MONITORING YEAR 1 ANNUAL REPORT

DEEP MEADOW MITIGATION SITE

RE: Deep Meadow Mitigation Site-Year 1 Monitoring Report
Final Submittal for DMS
Contract Number 006887, DMS# 97131
Yadkin River Basin – HUC 03040105; Union County, NC

Wildlands Engineering, Inc. (Wildlands) has reviewed the Division of Mitigation Services (DMS) comments and observations from the Deep Meadow Mitigation Site Draft Year 1 Monitoring Report. The report text has been revised for the final draft to reflect the most current condition of the site. The following are your comments and observations from the report and are noted in **Bold**. Wildlands' response to those comments are noted in *Italics*.

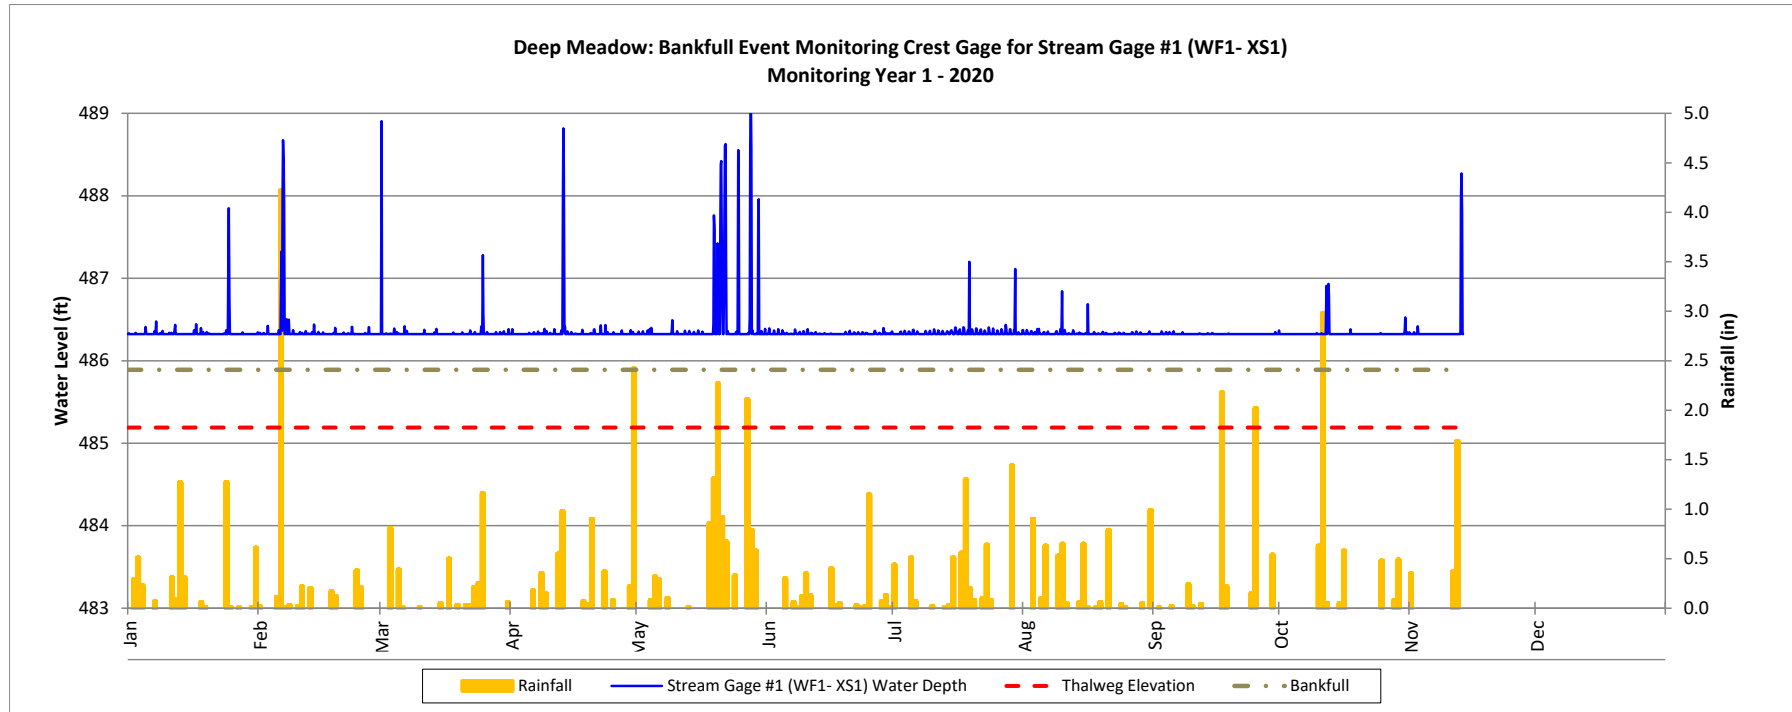
DMS Comment: Digital Support File Comments: Please add the figure for Stream Gage #1 to the report.

Wildlands Response: The figure for Stream Gage #1 has been added to the report. Please note that the gage was accidentally installed above the bankfull elevation as reflected in the plot. Gage #1 will be lowered in the winter of 2020 to capture all events in MY2.

Wetland W-E6

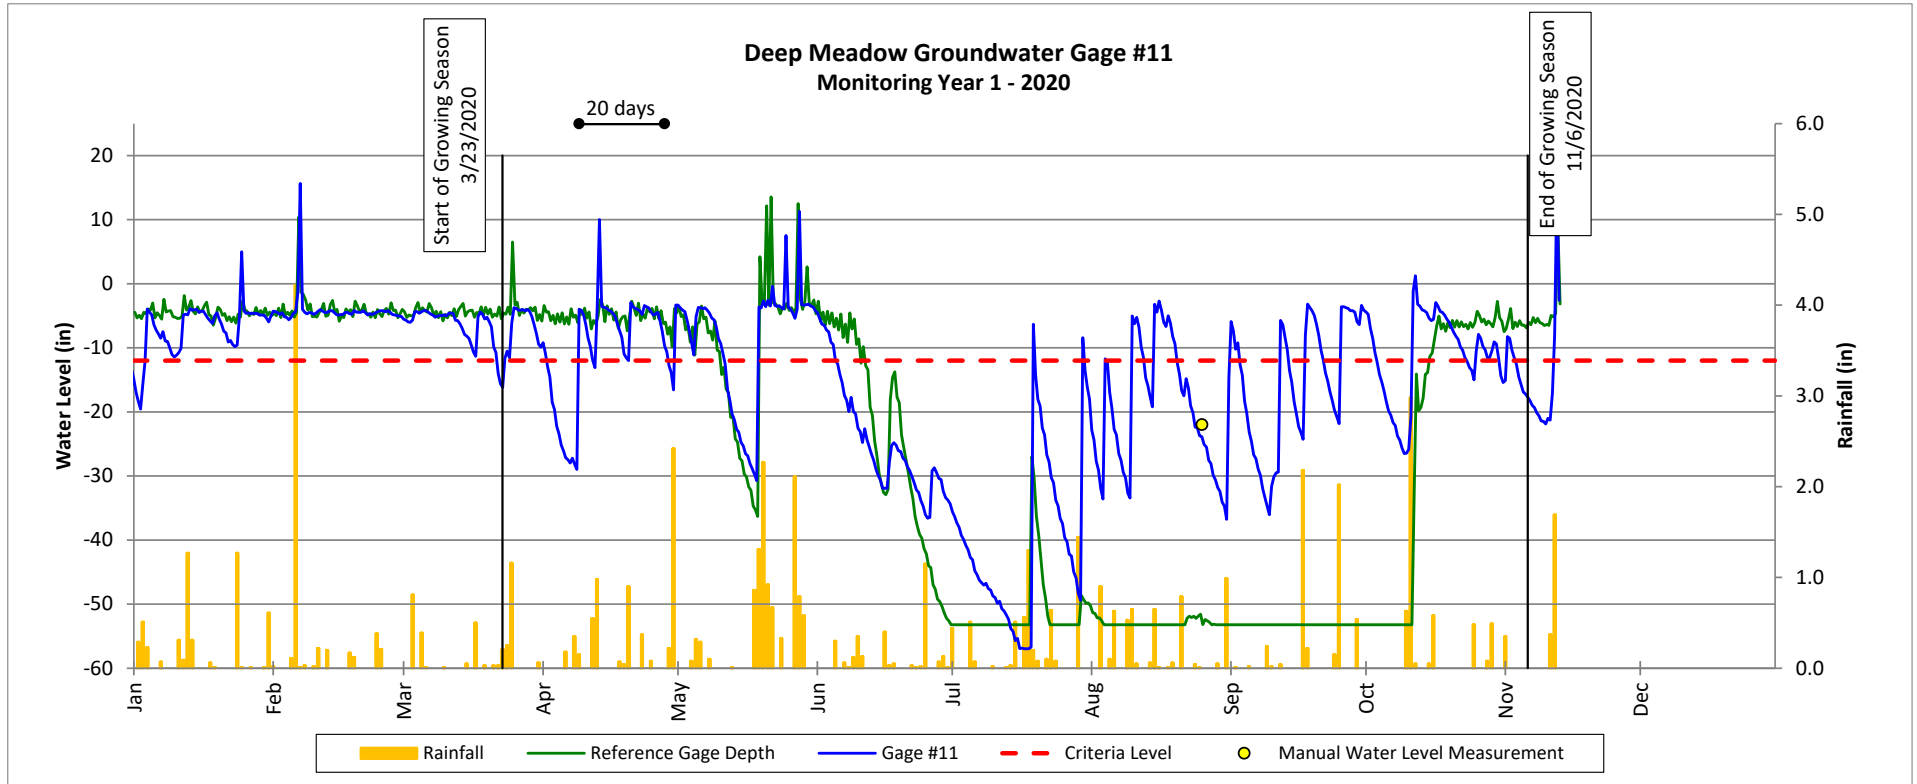
DWR Comment, Erin Davis: Groundwater gauges 3 and 11 appear to be located outside of wetland reestablishment credit areas. If these gauges were placed to demonstrate additional wetland area, that's fine. But DWR would like groundwater gauges installed within reestablishment areas W-E6 and W-E8 as specified in the approved mitigation plan to demonstrate success of the wetland hydroperiod performance standard.

Wildlands Response: The current location of these wells is as close to the Mitigation Plan's proposed gage location as possible. Multiple holes were bored in the areas surrounding the Mitigation Plan's proposed gage locations; however, installation was difficult due to a shallow layer of bedrock where refusal was reached at approximately 3 - 4 feet. Though the resulting locations for GWG3 and GWG11, at the edge of the proposed wetland boundary, is not optimal, it is the assumption that if the wetland meets criteria on the edge wetland boundary, the remainder of the wetland will also meet. Results from groundwater monitoring from MY1 are reflective of this assumption with GWG3 meeting the performance criteria and GWG11 just barely missing the success criteria of 10% with a rate of 8.7%. If GWG11 continues to not meet the success criteria for wetland hydrology in subsequent monitoring years, Wildlands will install another well closer to the center of W-E6.
